1119 Wireless Sounder

October 2011

Hardware Update

Updated Hardware

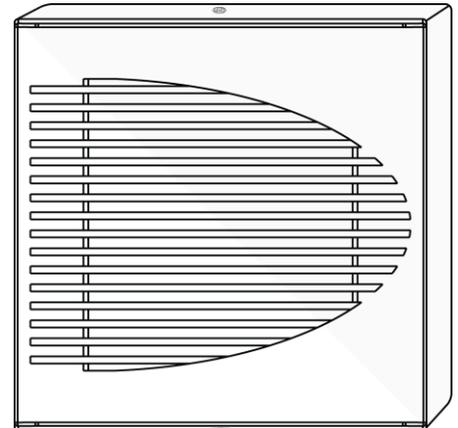
To accommodate the louvered housing, the zone terminal block has been reversed. The non-polarized zone wiring now enters the terminals from the right side of the block as shown in the diagram.
